Architectural Review and Historic Preservation Board Agenda Report

File : AR 20-07

RE: North Creek Crossings
East Side of Notre Dame Boulevard, North of Little Chico Creek in Meriam Park

Sheet Title
LANDSCAPE MASTER PLAN

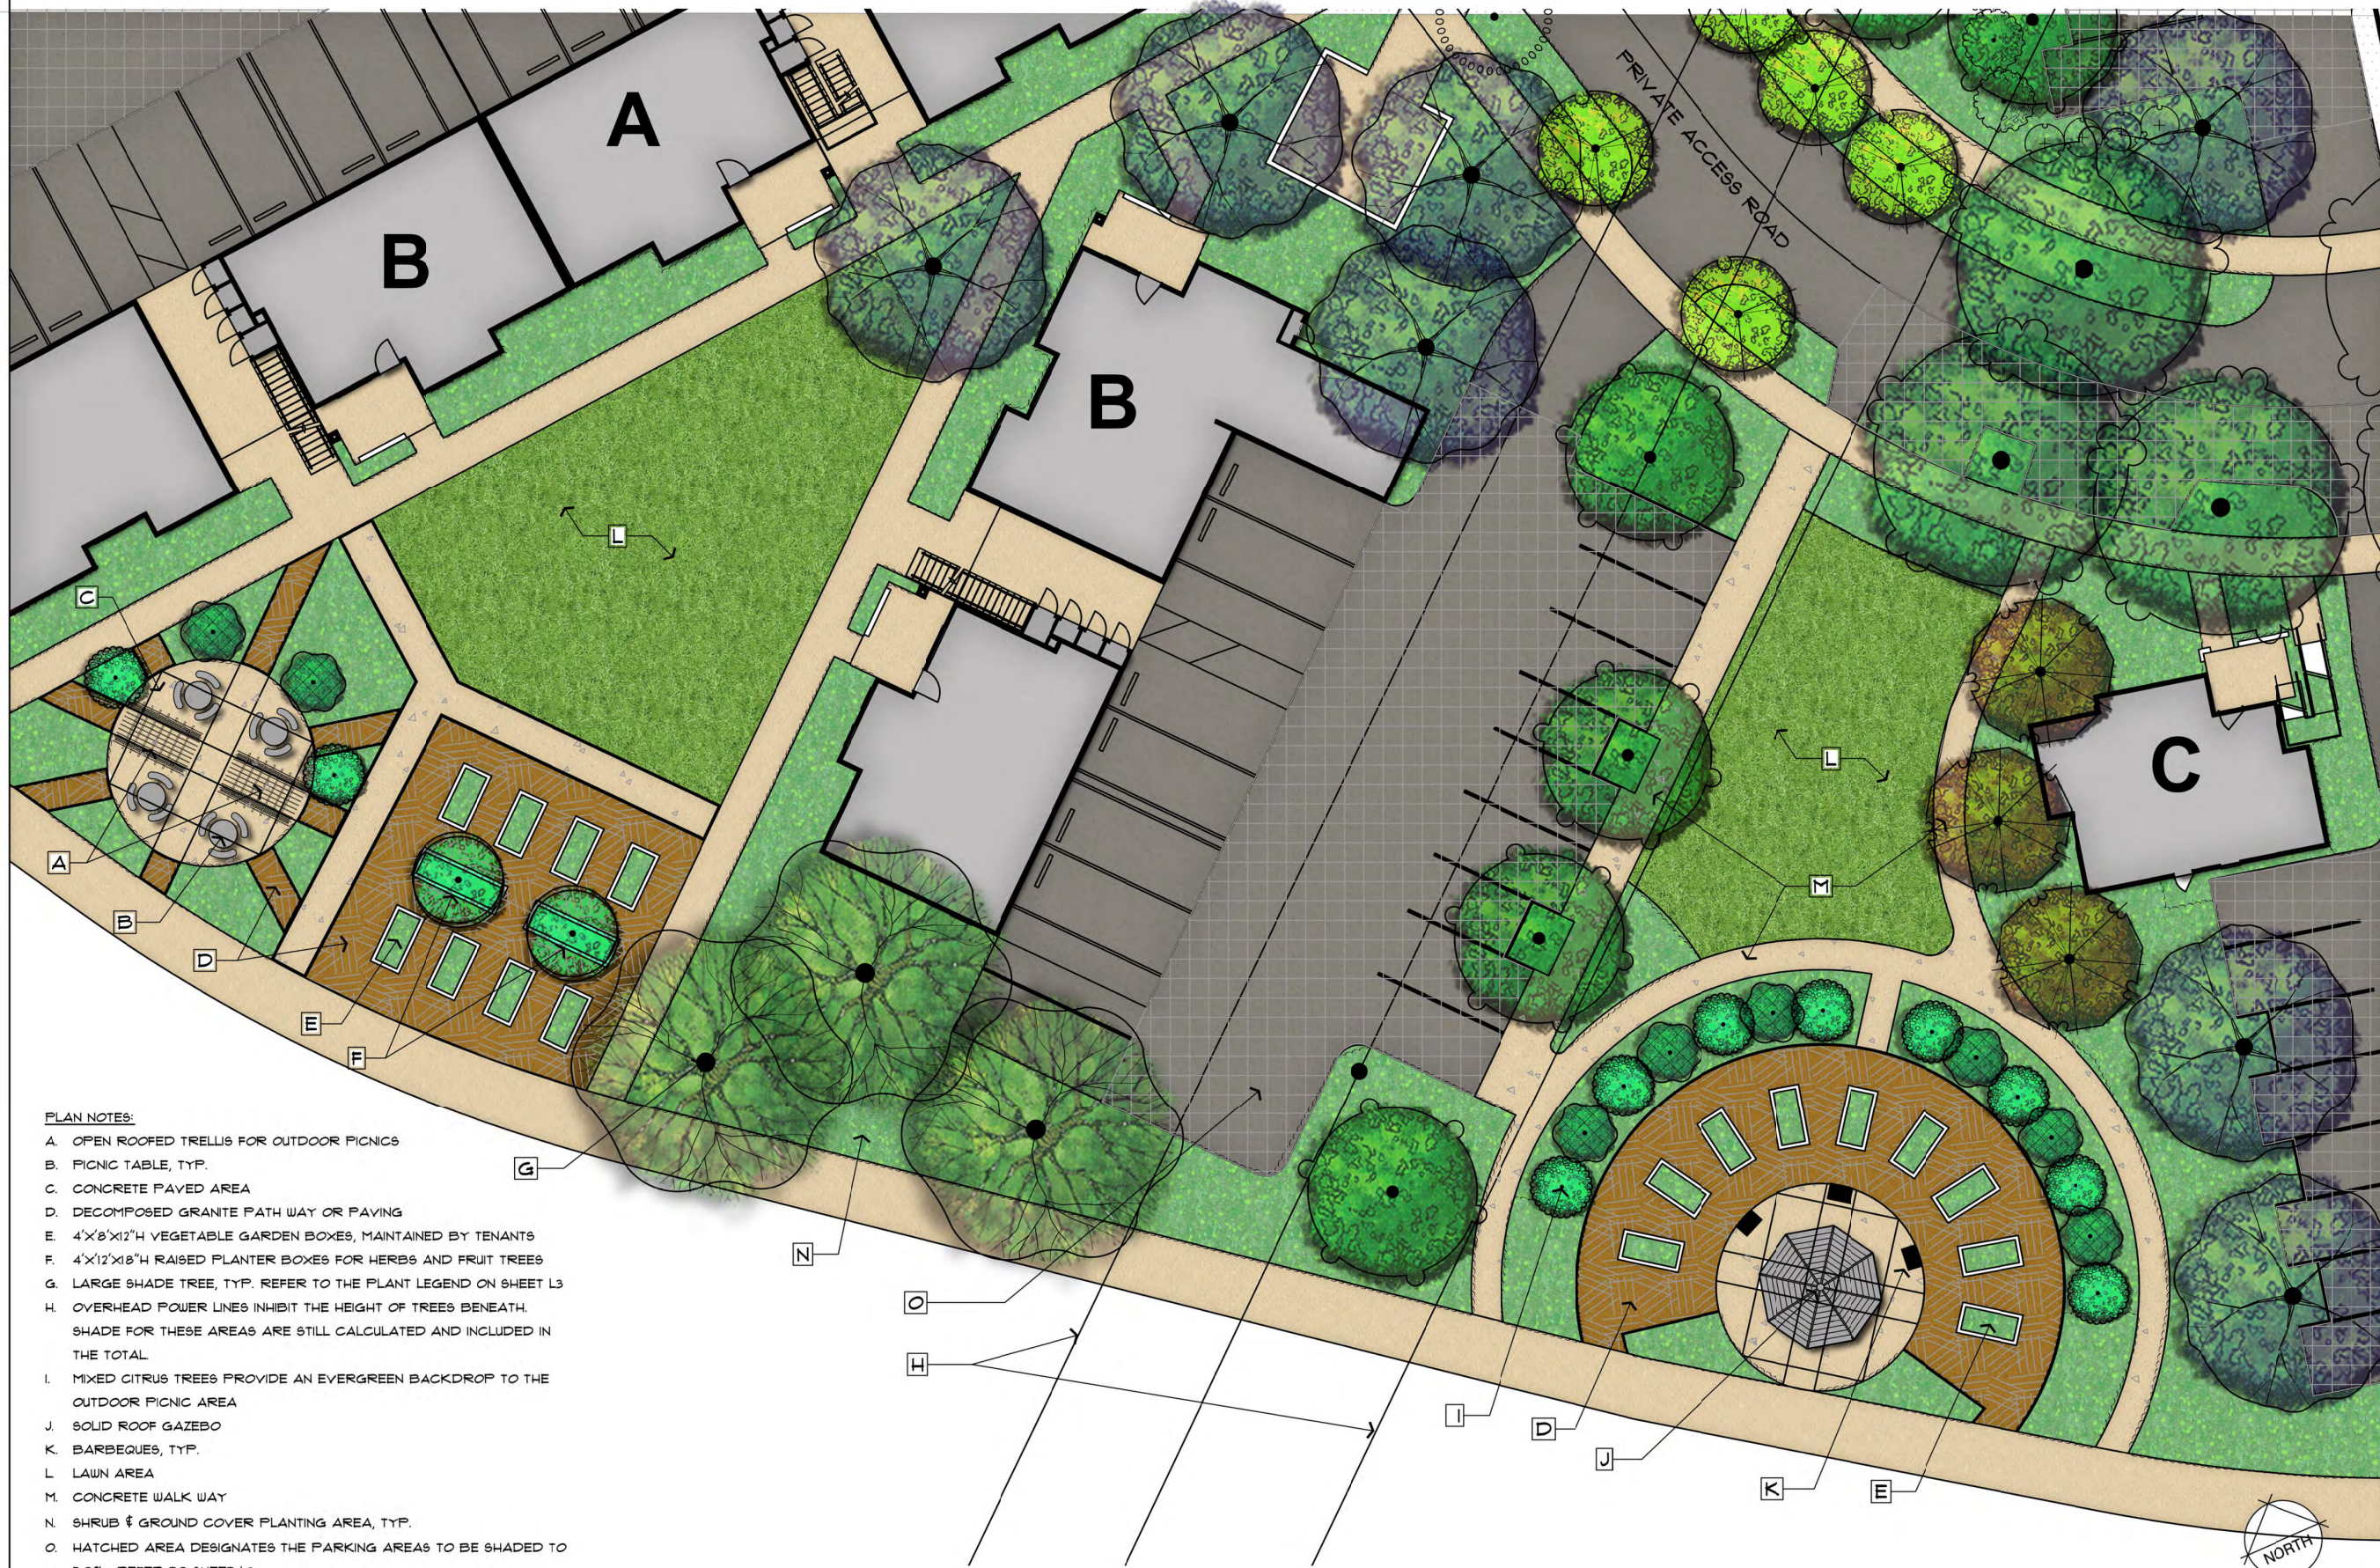
3. Enlarge the 8-ft by 8-ft interior parking lot planters to be at least 8-ft by 16-ft, or otherwise double their size to increase soil surface area around parking lot shade trees.
